# **Task Force on Harbourfront Developments on Hong Kong Island**

TFHK/02/2017

## **The Urban Design Study for the Wan Chai North and North Point Harbourfront Areas**

### **Proposed Major Refinements to the Harbourfront Enhancement Proposals**

Title: **Refined Master Layout Plan**

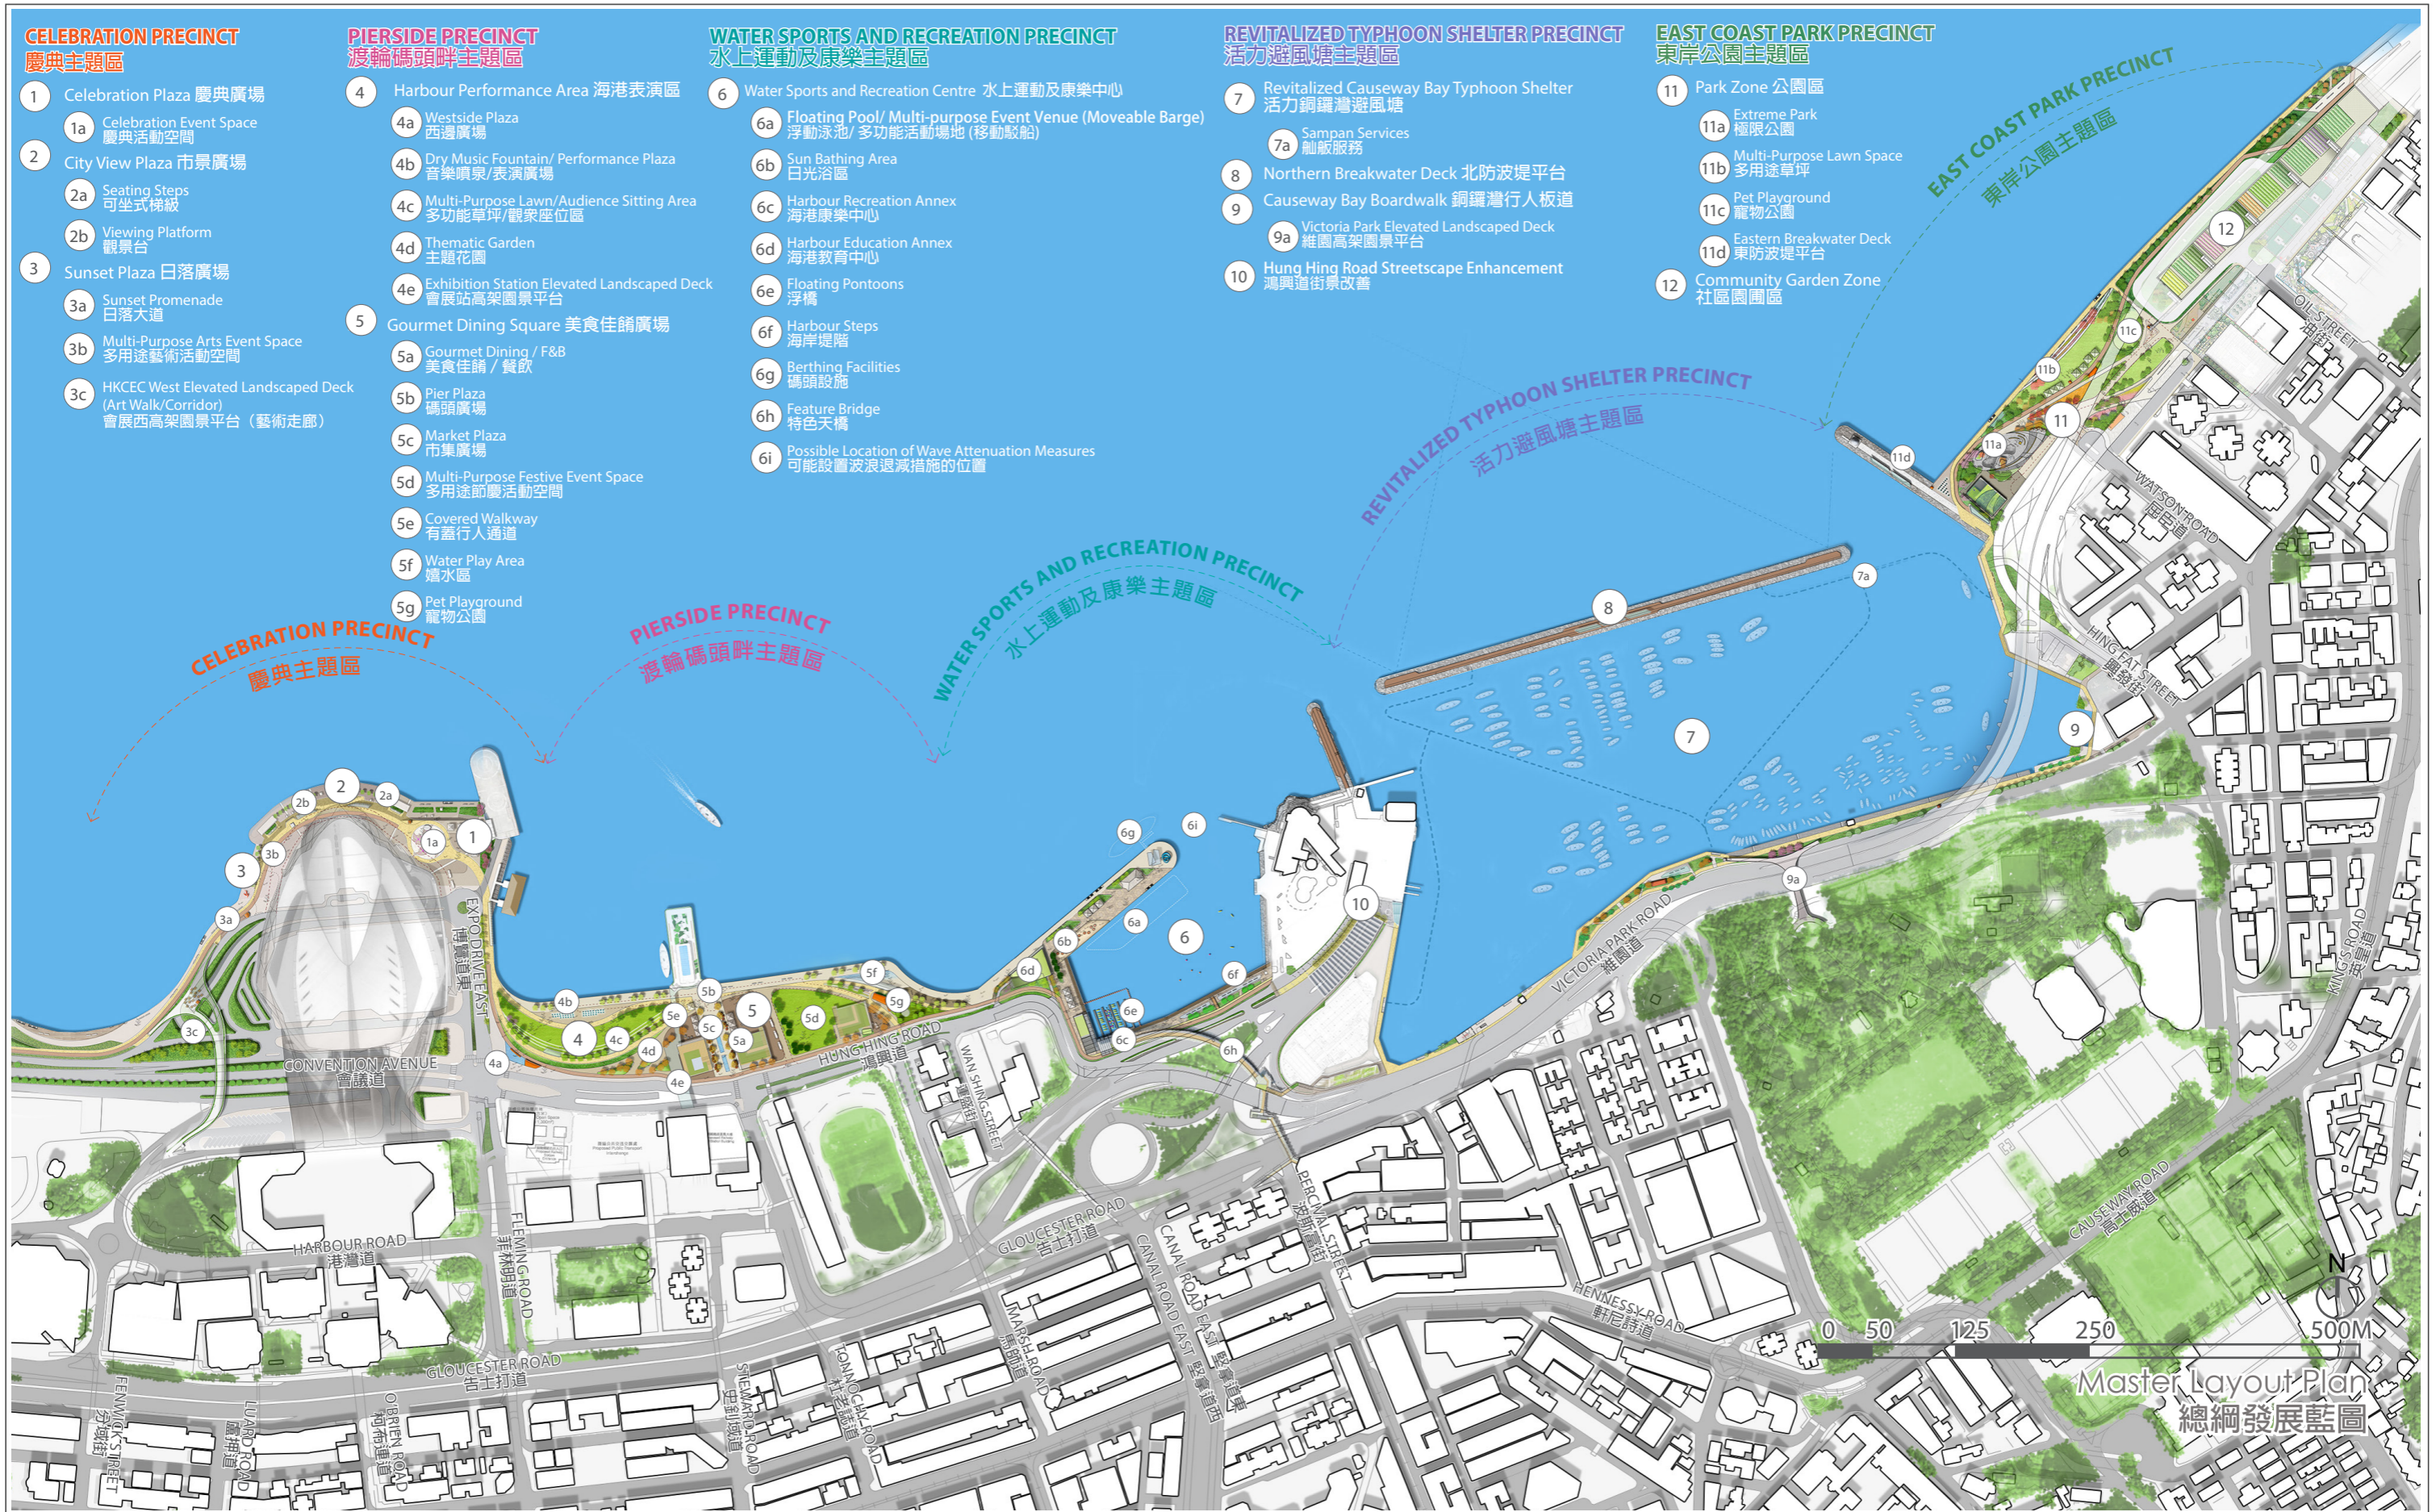
- (a) Extended cantilevered structure - Members considered that the proposed cantilevered boardwalk structure with columns to be erected on the seabed would be interpreted as reclamation under the Protection of the Harbour Ordinance (PHO). Members noted the benefits in terms of connectivity that could be brought about by the cantilevered boardwalk proposal along CWBTS and were aware that any attempt to proceed would need to be preceded by satisfaction of relevant PHO requirements.

- (b) Shared use and cycle trail - Members considered that shared use of the waterfront should be encouraged while the existing narrow bottleneck sections would have to be accepted and accommodated. Different users including cyclists and pedestrians should be able to adapt and make best use of the existing constrained areas. The need to design a standardized cycle track on the boardwalk through reclamation might not be substantial.

- (c) Hung Hing Road streetscape enhancement - Members considered all existing metered parking spaces along Hung Hing Road should be removed to allow more space for streetscape enhancement. The public should be well informed that no parking spaces would be planned for the site and the parking demand should be able to be managed.

5. Taking into account the above comments, the HEPs are being further adjusted (**Annex A**) and the major refinements are summarized in the ensuing paragraphs-

- (a) Taking into account Members' views on shared use and public aspirations of having a continuous cycle trail, the cycle trail proposal has been reviewed with a view to providing a continuous cycle trail from Wan Chai North to North Point without the need to require the cyclists to dismount their bikes. Under the refined proposal, cycle trail is proposed along the whole stretch of the harbourfront area, except three sections, i.e. an area near the Golden Bauhinia Square in Celebration Precinct, a small section of Hung Hing Road near RHKYC and the promenade along CWBTS. Suitable shared use arrangement would be adopted in these sections due to severe pedestrian flow and/or physical site constraints.

- (b) During PE2, a cantilevered boardwalk along CWBTS promenade was proposed to enhance the pedestrian environment. The public responses received were in general supportive. Besides, there was strong request for a continuous cycle trail along the waterfront. To address this public aspiration, the refined HEPs as presented to Members at the Working Group meeting on 22 March 2017 included an extended cantilevered boardwalk with a dedicated 3.5m-wide cycle trail.

- (c) Members' comments in relation to PHO implications of the proposal were noted. We have looked into a scheme of a waterfront promenade without the cantilevered boardwalk. However, a number of sections along the promenade will then be very narrow, particularly the section near Hing Fat Street, the situation of which would be even more constrained due to the complete lack of land at the waterfront for a continuous connection. Given that the ultimate intention is to ensure the provision of a continuous waterfront promenade, and that the Harbourfront Commission is separately deliberating on PHO issues, we propose keeping the cantilevered boardwalk proposal as an option in our study bearing in mind the PHO implications in further assessments. As the HEPs would likely be implemented by phases, the timing for

- (e) The latest assessment suggests that the overall greening ratio of the study area, after implementation of HEPs, could reach about 30% (in which about 40% would be occupied by tree planting), and a shading ratios of about 25% (mainly comprising tree canopies, pavilions and other shade structures, but excluding sheltered space underneath buildings or flyover structures) for the whole stretch of the waterfront could be feasible. According to the design concepts of the character precincts, a considerable amount of land areas could be flexible uses for multiple functions such as organizing events. Full coverage of tree planting might not allow sufficient design flexibility during the implementation stage.

- (g) Under the refined HEPs, there are a total of about 25 planned/existing landing steps. Subject to the loading capacity of the existing and planned seawalls, bollards will be provided throughout the whole stretch of the waterfront to serve various marine uses. Associated facilities such as sheltered seating, lighting and kiosks are proposed at appropriate locations.

operational costs, and PHO implications, wavebrake is considered as the most suitable wave attenuation solution for the Water Sports and Recreation Precinct. It is a multiple buoyant modular system utilizing tire-like materials for the purpose of wave energy extraction. It operates by channeling wave and water into a series of constrictions and voids that will dissipate the water wave energy by hydraulic resistance and friction. Being a floating modular system, it requires neither permanent structure nor piling structure on the seabed, and could be easily customized for different configurations to cater for specific situations. Technical details of the wavebrake can be found in the website (<http://www.wavebrake.com/>).

- (i) To address the public's aspiration (in particular the strong request from the Wan Chai District Council) for providing pet facilities within the Wan Chai District, a pet playground of about 700m<sup>2</sup> has been added to the Pierside Precinct, in addition to the one being proposed in the East Coast Park. It should be emphasized that the entire Wan Chai and North Point waterfront is designed to be a pet-friendly public open space to be shared by different users including pets and pet owners.

- (j) Within the Celebration Precinct, minor adjustments were made to the alignment of the Emergency Vehicular Access (EVA), proposed locations of the food trucks, greening proposal near the helipad etc. The proposed seating steps have also been modified to cope with existing site conditions. Some proposed pavilions have been rearranged to allow flexibility during event days.

- (k) For the Water Sports and Recreation Precinct, the floating barge pool is indicated as a possible option. Refinements were made in respect of the size of the urban beach, the footprint and bulk of the Harbour Education Annex building, the extent of the Harbour Steps and the arrangement of amenity strips. Taking into account the potential PHO implications and Members' comments to allow flexibility for marine use of the outer water space along the finger breakwater of the Wan Chai Basin, the originally proposed berthing pier is deleted.

- (l) All metered parking spaces along Hung Hing Road are proposed to be removed for streetscape enhancements and a Lookout Plaza is

proposed at the end of Hung Hing Road.

- (m) In the East Coast Park, refinements were made for the configuration of the Extreme Park with skating and BMX facilities. The alignment of proposed cycle trail has been adjusted to connect with the latest scheme proposed for the Boardwalk underneath Island Eastern Corridor Study.
